THE ANSI/ANS STANDARD 58.2-1988: TWO-PHASE JET MODEL

Graham Wallis September 15, 2004

This memo critiques the methods described in the Standard, compares them with the referenced technical models and the probable reality, and also with independent calculations. The work has been performed quickly in order to

Figure 1 Pressure contours for a jet issuing between two discs⁴

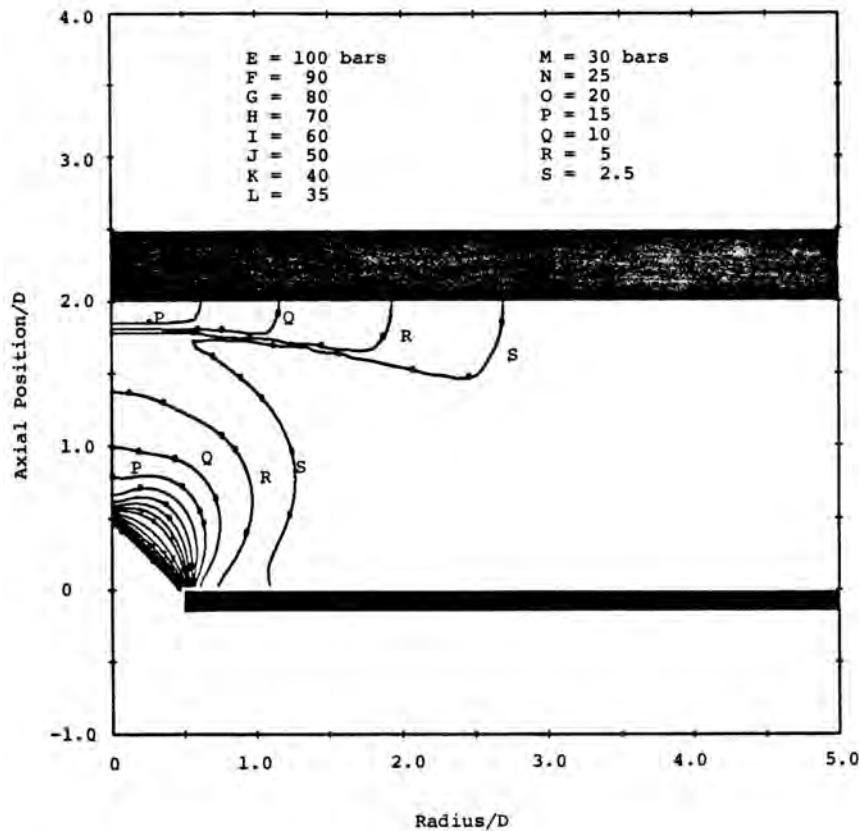
Figure 1 shows a "core" region in which there is no depressurization, rather than the usual situation where choking occurs at the exit plane. This may be a real effect as there is evidence from the Marviken tests of a region near the break where the stagnation pressure is fully recoverable; it doesn't matter for the far field at large distances from the break.

The jet is able to turn 90° and follow the inner wall, executing the familiar Prandtl-Meyer expansion. The contours of constant pressure near the nozzle resemble those from a point source to some extent.

Figure 2 Velocity vectors corresponding to Figure 1

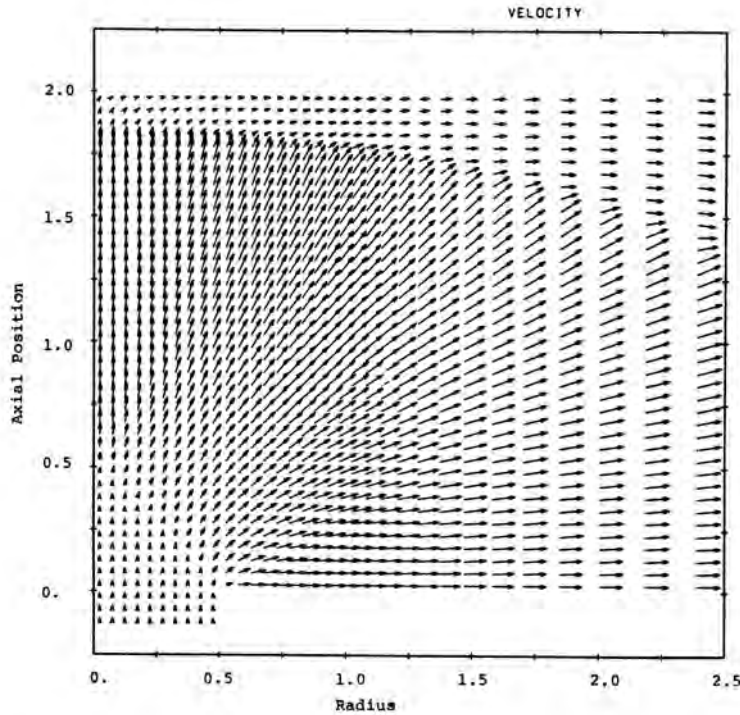
Figure 2 shows the corresponding velocity vectors. The supersonic flow undergoes a shock as it approaches the target plate. The shock is normal near the stagnation point and oblique further out. The calculation is not

These two problems are quite different. This is shown clearly by the velocity vectors in Figure 2. The only region where the two flow fields are the same is in a small region close to the nozzle that is unaffected by waves

Figure 3 Pressure distribution along the target plate⁴

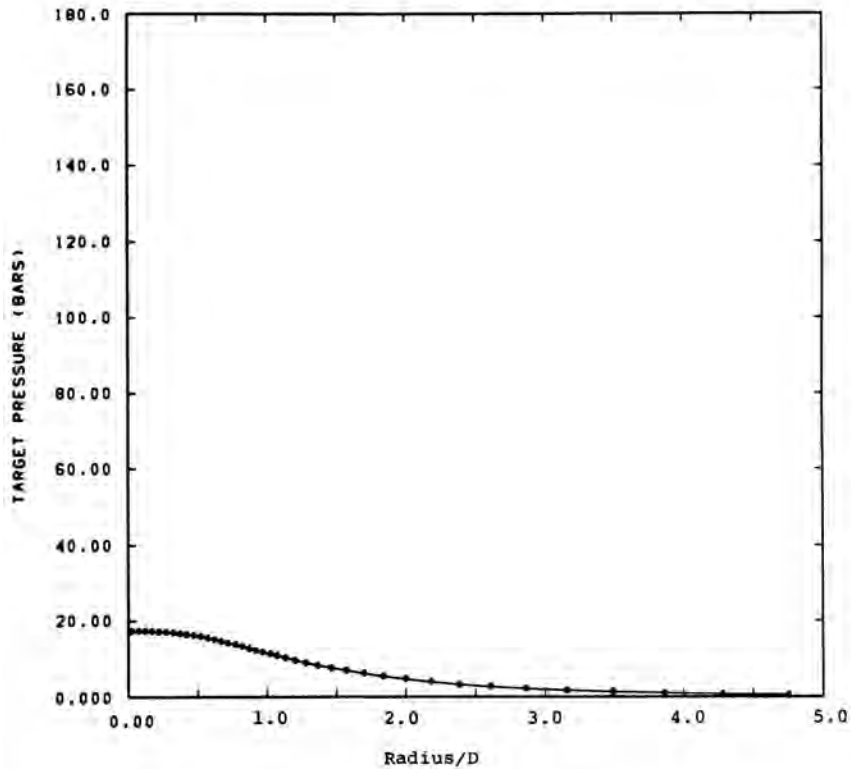
Figure 3 shows the pressure distribution on the large target disc. The pressure is seen to fall off with radius. Since the flow is inviscid in this model, the streamlines from the stagnation point flow along the surface, conserving stagnation pressure. This would be the maximum pressure felt by an object placed anywhere close to the target surface and it would be the same at all radii. For example, at $R/D = 2$, the static pressure on the target plate is about 5bar, but an object near the plate would experience the full stagnation pressure of 18bar.

Figure 4 Jet model in the ANSI/ANS Standard

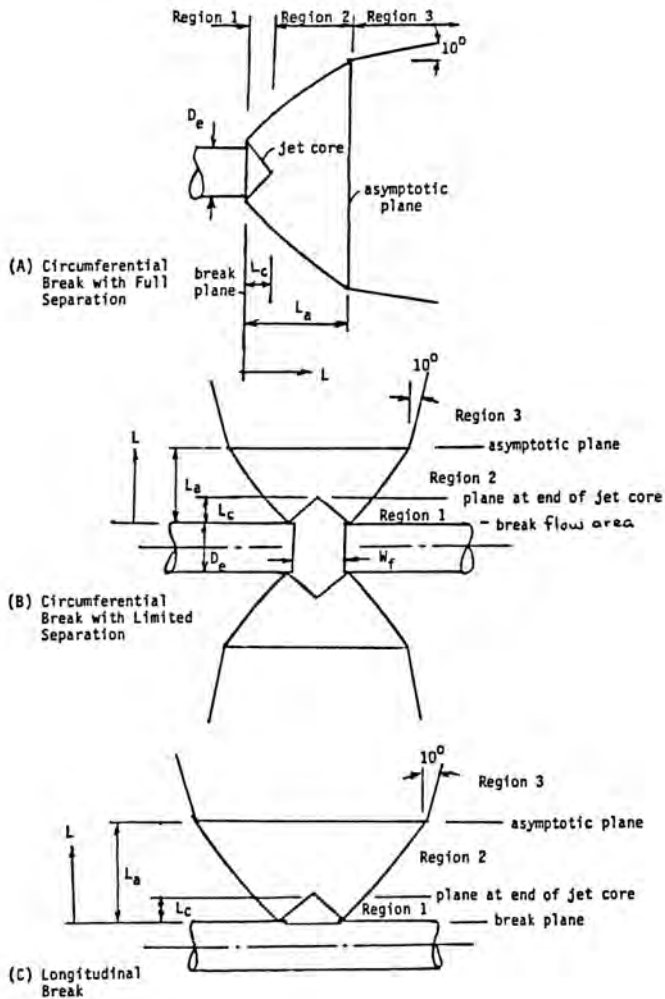
Region 2 follows the 45° cone assumed by Sandia. It ends at an "asymptotic area". For low subcooling this is where the pressure is predicted to be atmospheric. The area, A_a of the jet at this plane is computed from

In Region 3, "interaction with the surrounding environment is assumed to start" and the jet is then assumed to expand with a 10 degree exterior half-angle after the "asymptotic plane". There is no discussion of shock waves forming in front of obstacles. The assumption seems to be that all supersonic effects are over at the end of Region 2 and the jet behavior is thereafter governed by turbulent mixing with the surrounding fluid.

The concept that supersonic expansion stops at an "asymptotic plane" is not consistent with observation. In the Marviken tests, and according to theory, the mean pressure in the jet reaches ambient pressure at dimensionless distances from the nozzle, L/D_e or z/D_c , between 1 and 2. Figure 5 shows a schlieren photo of a supersonic jet expanding with about the same pressure ratio, p_0/p_a , as at the start of a LOCA. The jet expands for about 7 L/D then begins to contract and passes through a shock wave at around 10 L/D (it is unclear what the inside diameter of the pipe was). At much lower pressure ratios, as in the later stages of a LOCA, the jet initially expands much less, but it then passes through several shock diamonds, again out to around $L/D \sim 10$ (Figure 6).

The ANSI/ANS approach that all is over at an "asymptotic plane" at the end of Region 2, around L/D =1.5 or 2, does not seem to correspond to reality. Continued expansion at a half-angle of 10 degrees in Region 3 also appears to have no clear justification and may predict too low an impact pressure at high L/Ds. It would perhaps be desirable to make suitable CFD predictions, and compare with experimental results, for longer L/Ds than have been used so far.

Figure 7 Characteristics net used in reference 2

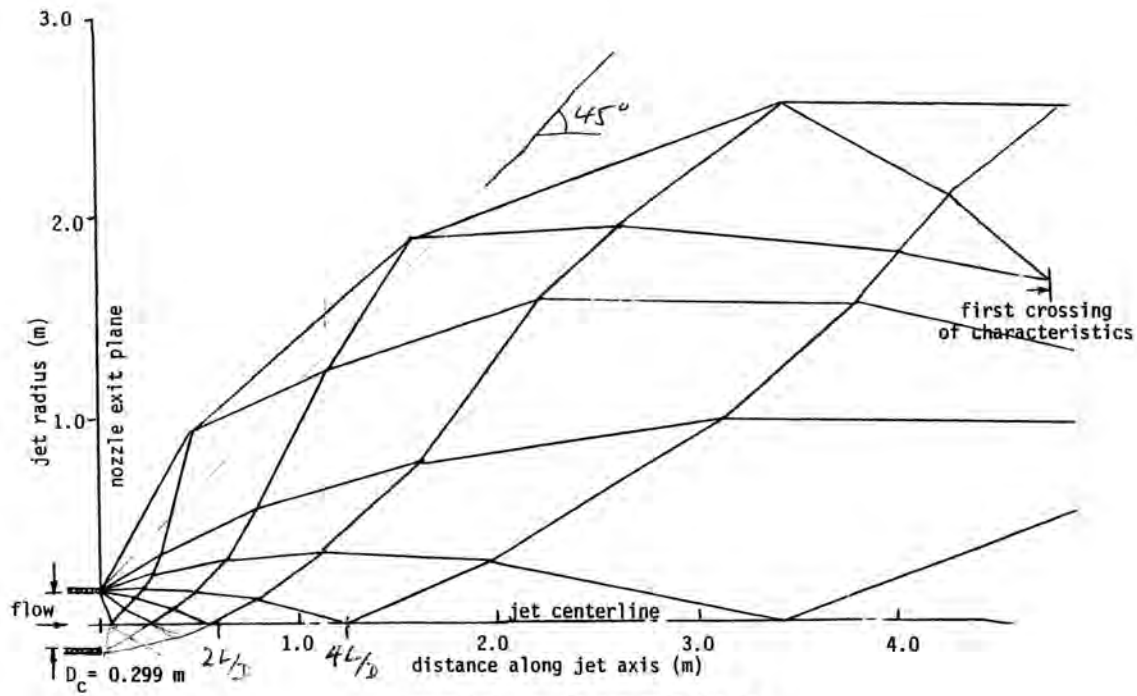
An expanding free two-phase steam-water jet is analyzed in EPRI NP-4362² using the method of characteristics. Figure 7 shows a typical characteristics net from that report. It can be seen to capture several of the features shown in Figure 5. Expansion of the jet continues to L/D about 12 before the envelope begins to contract.

At L/D_e =4 in Figure 3-4 the jet radius is about 1.5m, or D/D_e = 10. This would correspond in Table 1 to a mean pressure of about 0.015MPa. Since the outside of the jet is still at 0.1MPa, if the ambient pressure is 1bar, it would appear that the centerline must be at an even lower pressure than the average value, perhaps around 0.01MPa. This occurs because expansion waves keep arriving on the axis from both sides. Similarly, at L=1.7m, L/D_e=5.7, the jet radius is 2m, D/D_e=13.3 and the average jet pressure is below 0.01MPa while at L=3.5m, D/D_e =16.7 and the average pressure is

After a distance of 4m the jet begins to contract. Some of the characteristics cross, indicating the formation of shock waves. If these are weak, the jet will collapse to conditions resembling those close to the nozzle, in the absence of other dissipative effects, as compression waves reflected from the free surface recompress the fluid. Then the impact pressures on targets will increase with distance from the nozzle. However, it appears from Figures 5 and 7, that there will be a normal shock at about $L/D = 16$ which will limit further significant refocusing of the jet energy and momentum.
